# 1980 Corvette: Service Bulletin: Rear Wheel Spindle Yoke Snapping Noise

**Source:** Chevrolet Dealer Service Technical Bulletin

**Bulletin No:** 80-T-44

FIGURE 1

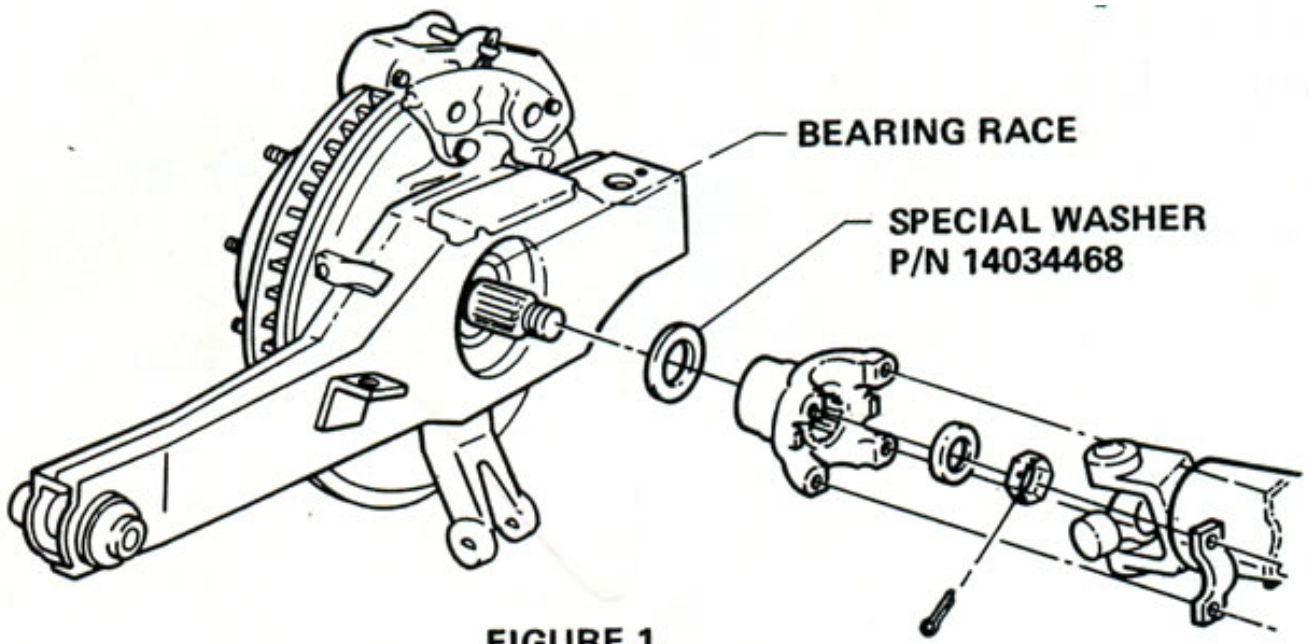
Owners of 1980 Corvettes, primarily those equipped with a manual transmission, may experience a snapping or crunching noise from either or both rear wheel locations during torque reversals and during acceleration or deceleration. This noise is the result of scuffing of the rear wheel spindle yoke against the inner wheel bearing inner race.

This condition can be corrected by installing a special Moly coated washer (P/N 14034468) between the spindle yoke and the inner wheel bearing (see Figure 1). Steps 2 through 8 of the following Service Procedure should be performed at each rear wheel.
